Access Compliance Report

Public Rights-of-Way

(Curb Ramps)

Intersection ID: N/A	Main Street: E 4TH ST	Cross Street: N/A	Location: N
ADA ID: D7621E4CF6FC	Ramp Type: PerpDiag	Initial Pass/Fail: Fail	Overall Compliance: No
		Severity Score: 37.5

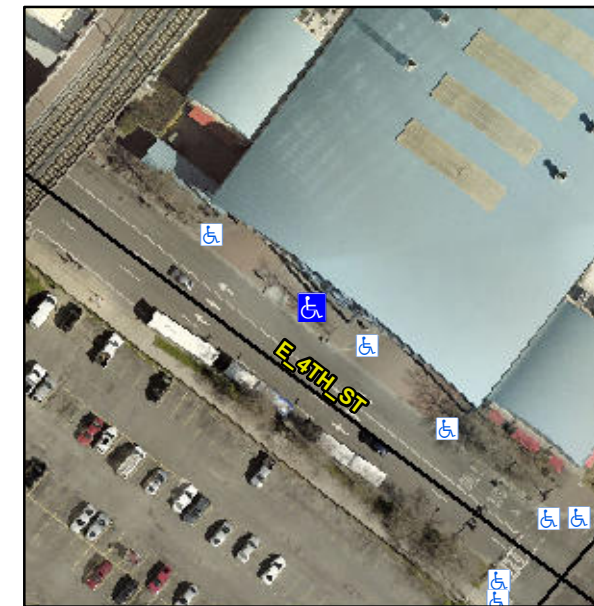
Not Found, R304.2.2, R304.5.3

Compliance	Description	Data	Compliance	Description	Data
N/A	Ramp Length (in)	96.0	No	Ramp Slope (%)	9.3
Yes	Ramp Width (in)	48.0	No	Ramp XSlope (%)	9.0
N/A	Flare Type LT	N/A	N/A	Flare Type RT	N/A
N/A	Flare Slope LT (%)	N/A	N/A	Flare Slope RT (%)	N/A
N/A	Flare Traversable LT?	No	N/A	Flare Traversable RT?	No
N/A	Landing Length (in)	N/A	N/A	DWS Provided?	N/A
N/A	Landing Width (in)	N/A	N/A	DWS Contrast?	N/A
N/A	Landing Slope (%)	N/A	N/A	DWS Length (in)	N/A
N/A	Landing X Slope (%)	N/A	N/A	DWS Full Width?	N/A
N/A	Landing Curb? (Y/N)	N/A	N/A	DWS Offset (in)	N/A
N/A	Shared Landing?	N/A			
N/A	Gutter Ponding?	N/A	N/A	Gutter Slope (%)	N/A
N/A	Gutter Lip Ht (in)	N/A	N/A	Gutter X Slope (%)	N/A
N/A	Painted X Walk1?	No	N/A	Painted X Walk2?	No
	X Walk 1 Direction	To SW		X Walk 2 Direction	To SE
N/A	X Walk 1 Width (in)	N/A	N/A	X Walk 2 Width (in)	N/A
	X Walk 1 Slope (%)	0.9		X Walk 2 Slope (%)	5.1
	X Walk 1 X Slope (%)	8.6		X Walk 2 X Slope (%)	1.4

Remove & Replace Curb Ramp With Two New Directional Ramps or Equivalent.
